PREVOST

WARRANTY BULLETIN

WB23-16B

DATE :	November 2023	SECTION :	06 ELECTRICAL
EXPIRATION:	January 2026		
SUBJECT :	SOLUTION FOR BATTERY DRAIN ON VEHICLE NOT EQUIPED WITH A PREHEATER

Figure 1: H3-45 Harness location

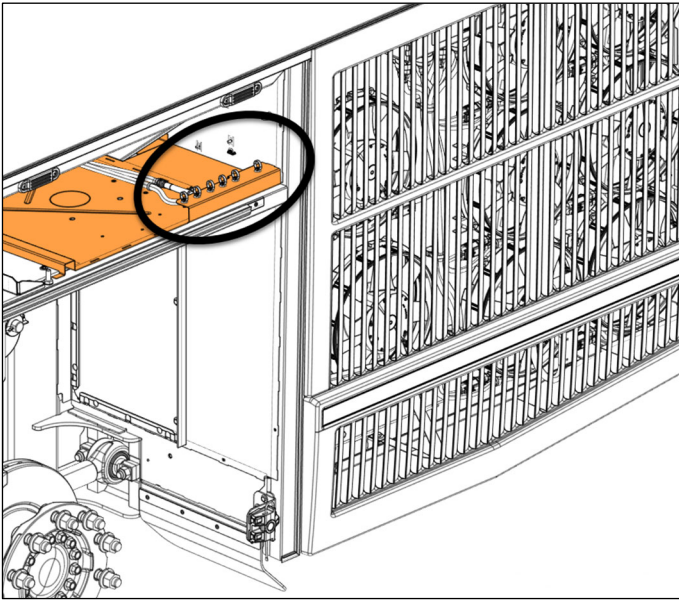
1. Locate the connector on the vehicle harness: refer to **figure 1** or **figure 2**

2. Unplug connector CSX1 and CSX3

3. On connector CSX1 install cap 564069. On connector CSX3 install cap 564660.

4. Secure harness with cable ties 504637 (4x).
